**Addendum #2**

**Bid Opportunity: RFT-2025-166 - Operations Centre Garage Expansion**

ADD  
#E01

ADD  
#M01

#### **1. REFERENCE DRAWING: E2 – ELECTRICAL LEGEND, SLD AND SCHEDULES**

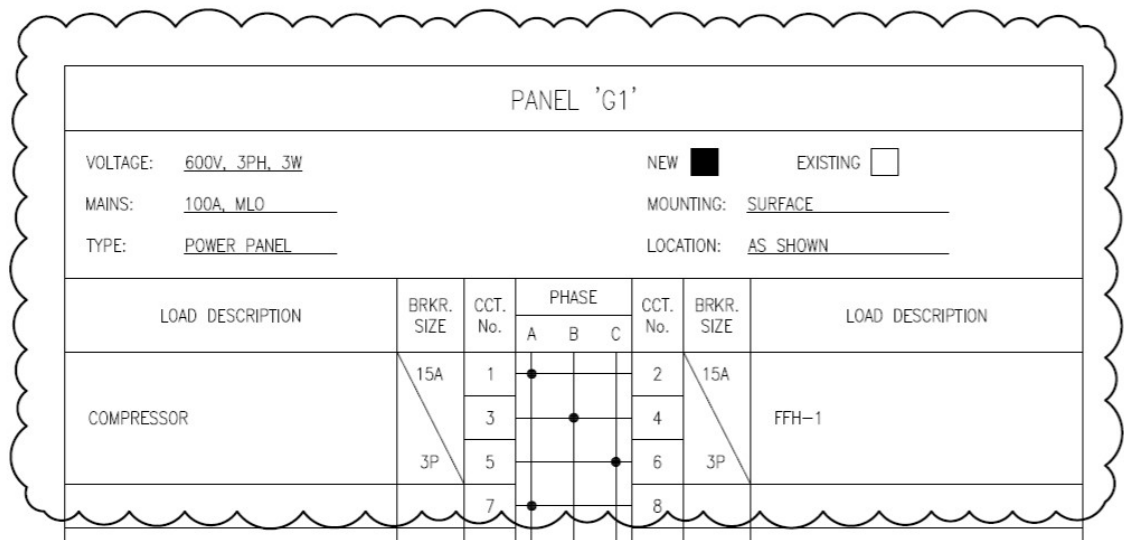
1. The 'G1' panelboard rating has been revised from 4-wire to 3-wire. Refer to sketch below for more information.

2. The circuit breaker within Panel 'G1' supplying the FFH has been revised from 347V,15A,1P to 600V,15A,3P. The circuiting has been updated to G1#2,4,6. Refer to sketch below for more information.

#### **1. REFERENCE DRAWING: M2 – HVAC PLAN (Re-Issued)**

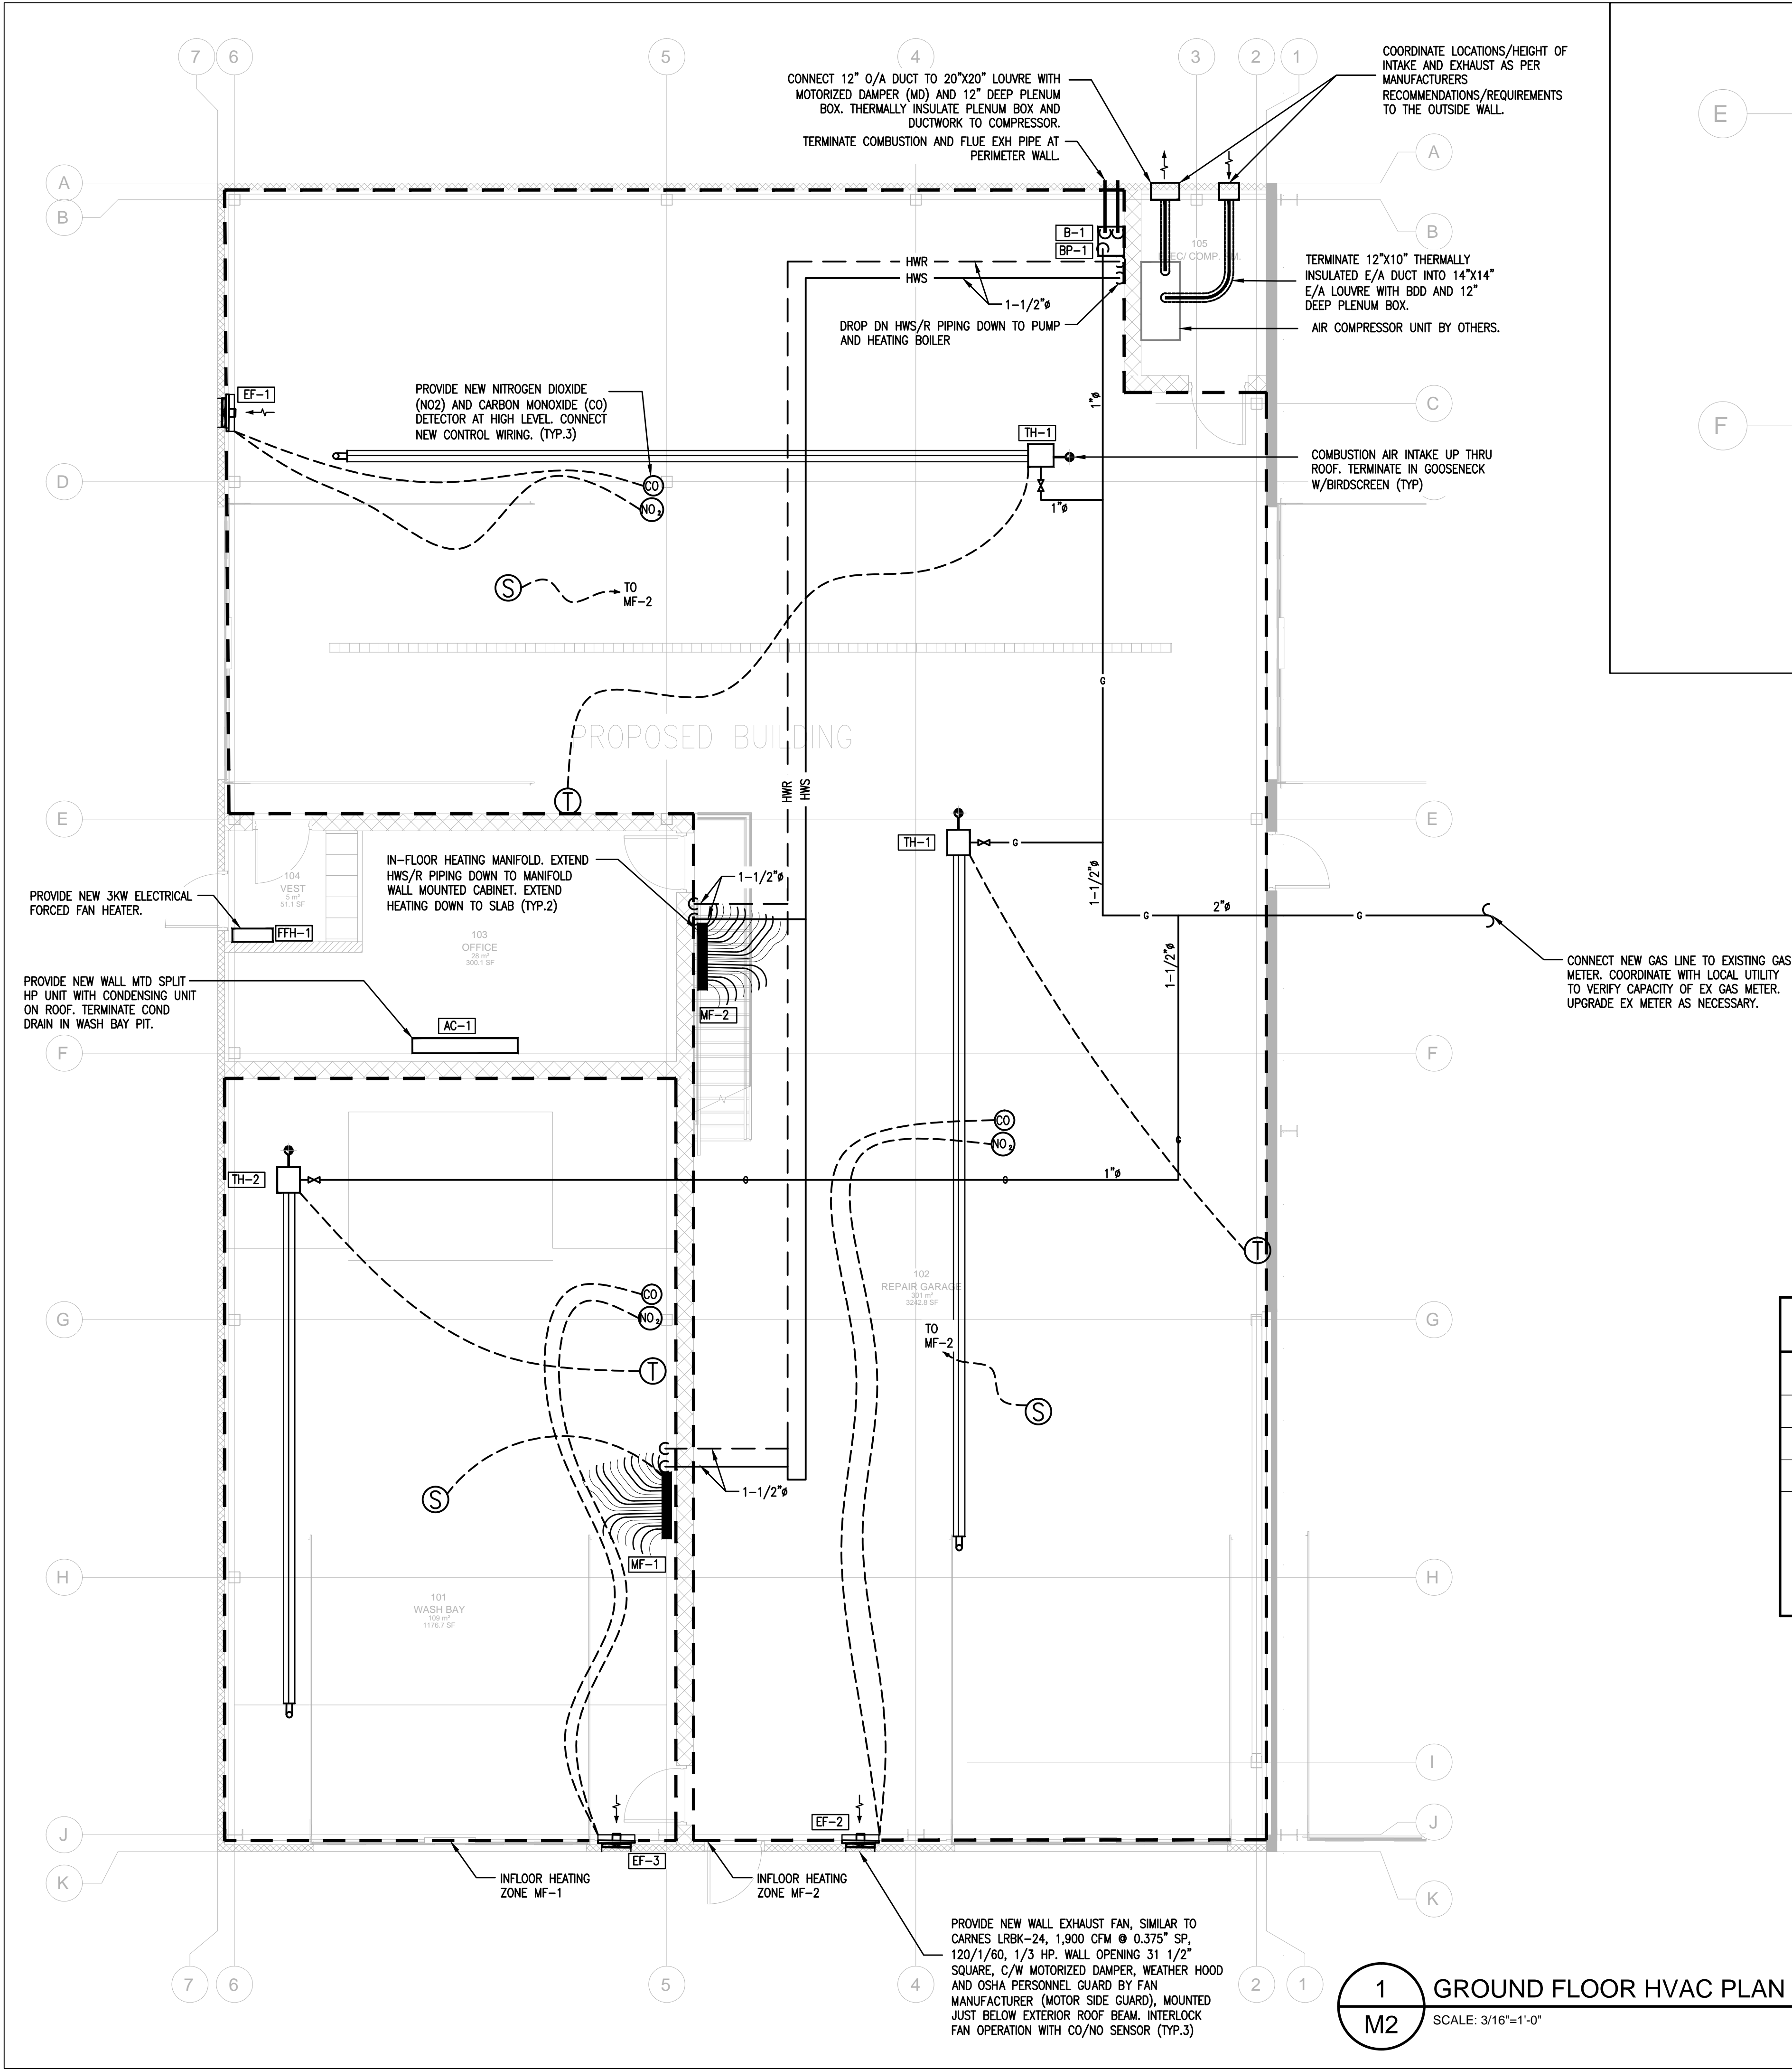
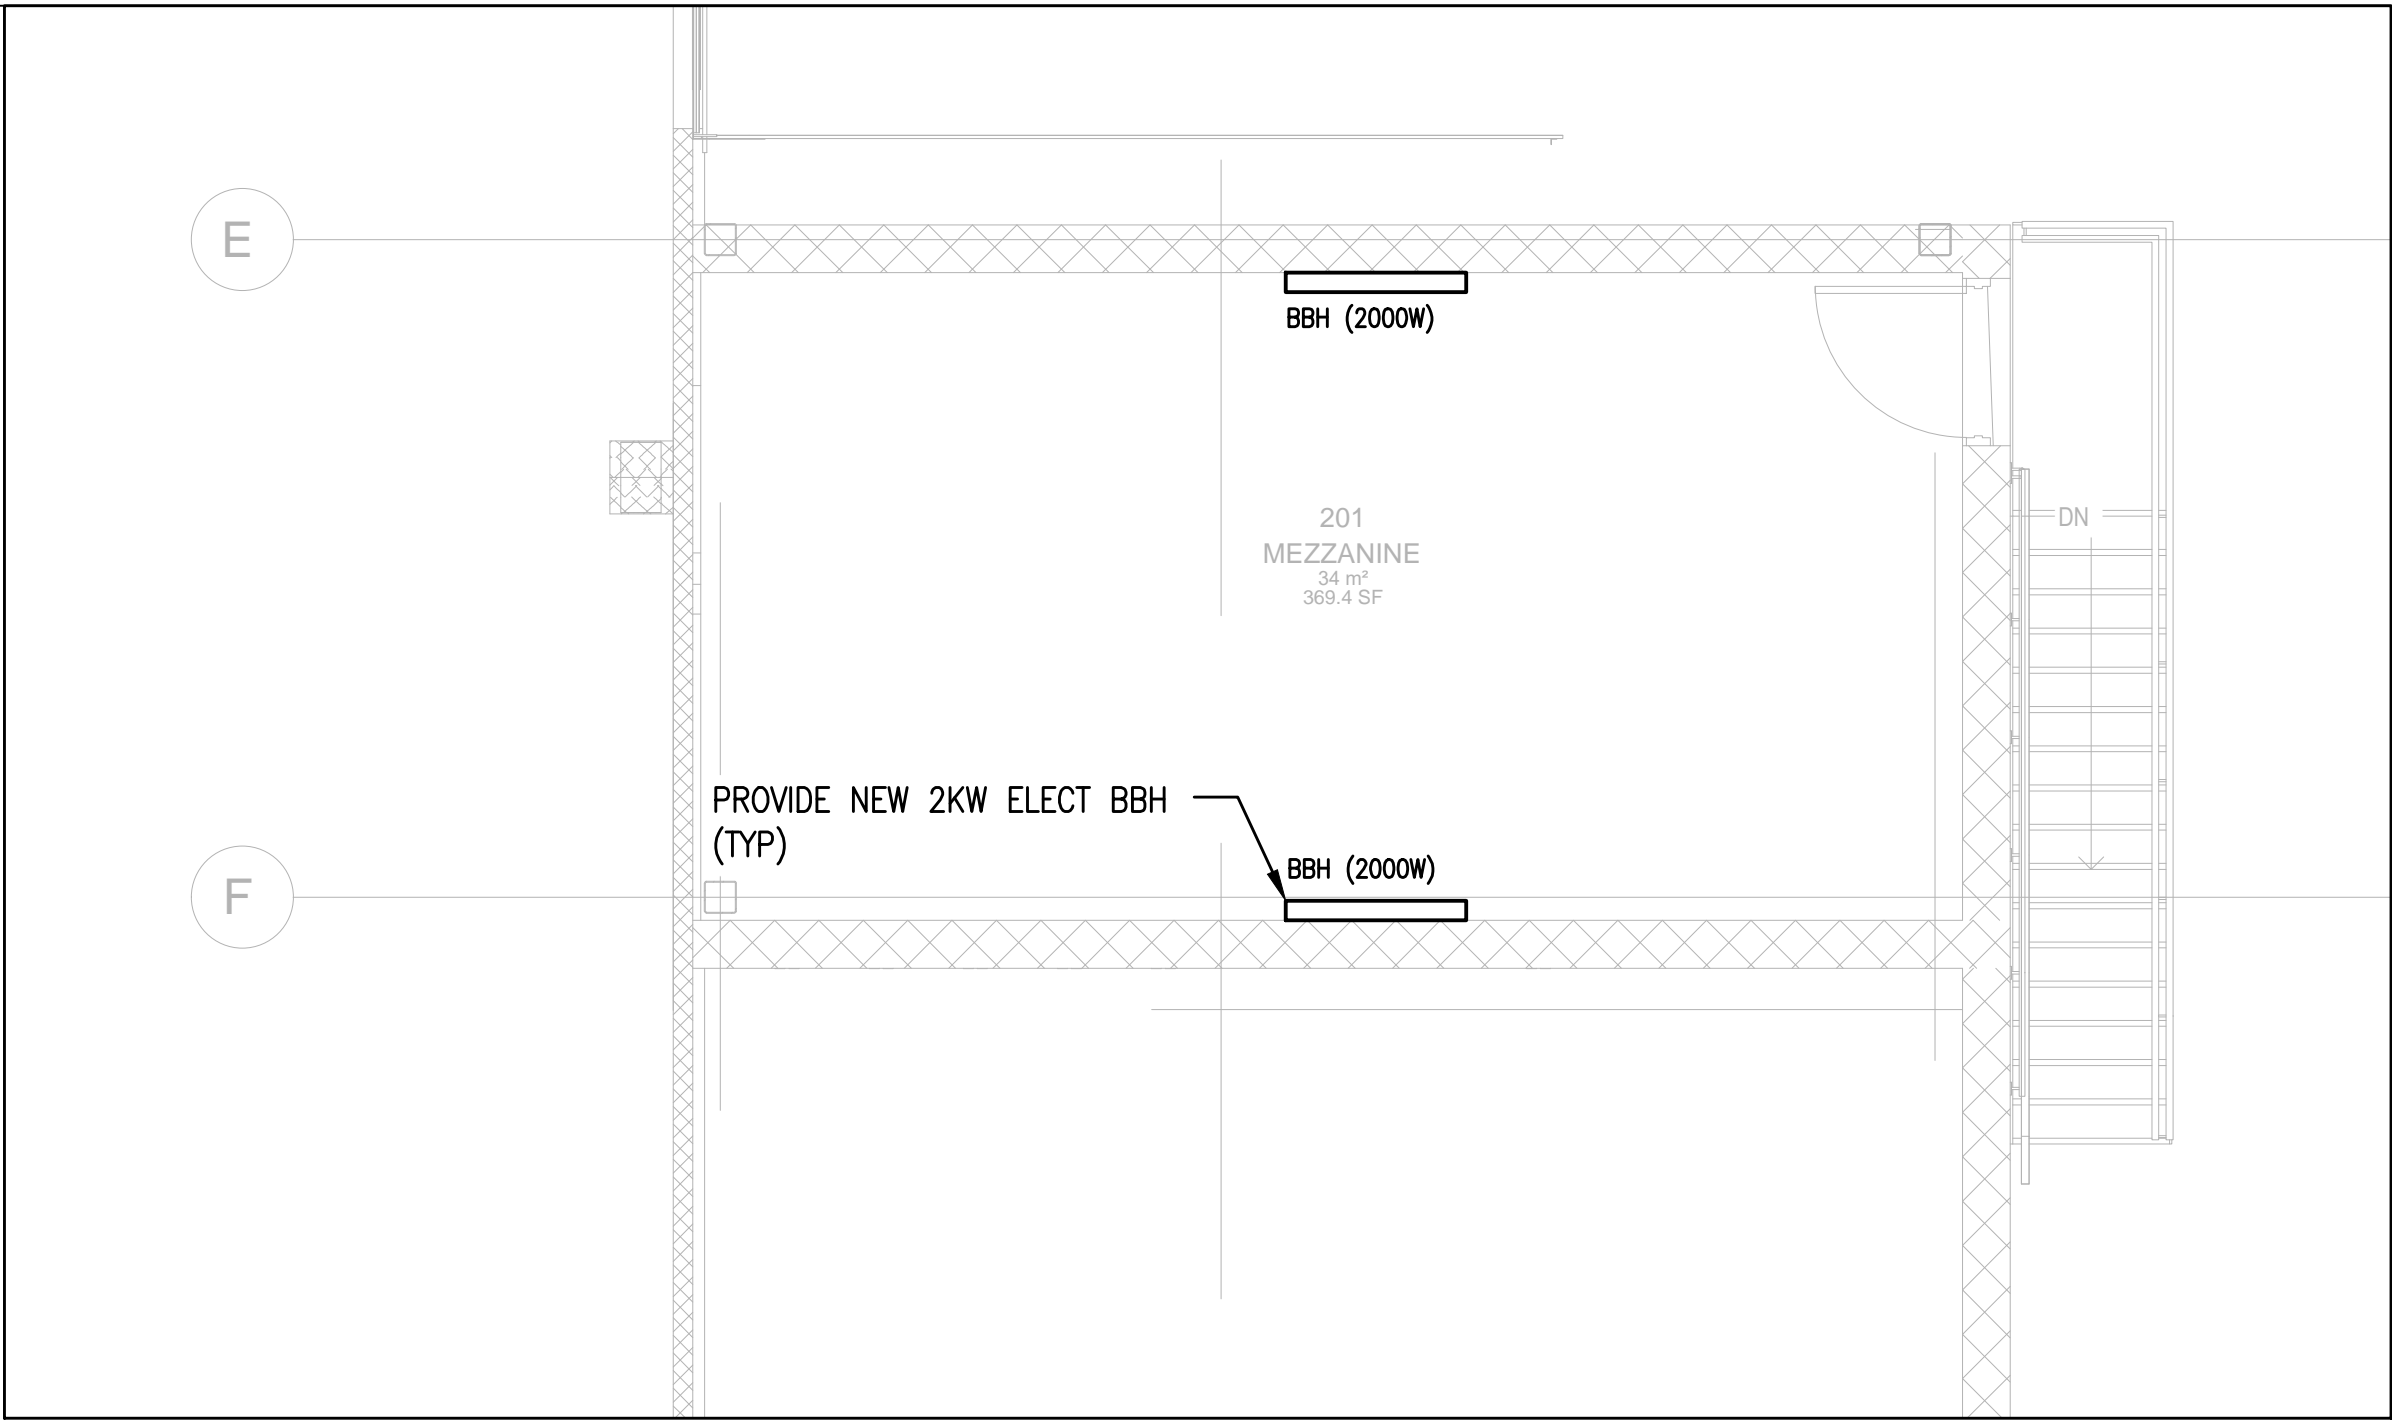
The Mechanical HVAC plan shows tube heaters. I cannot find tube heaters listed anywhere in the mechanical equipment schedules. Is this an over-sight or did I miss something?

1. Revised the location and quantity of tube heater.
2. Provided Radiant Tube Heater Schedule

**Answer 2: See attached Mechanical addendum (#M01- one page) with updated drawing M2.**
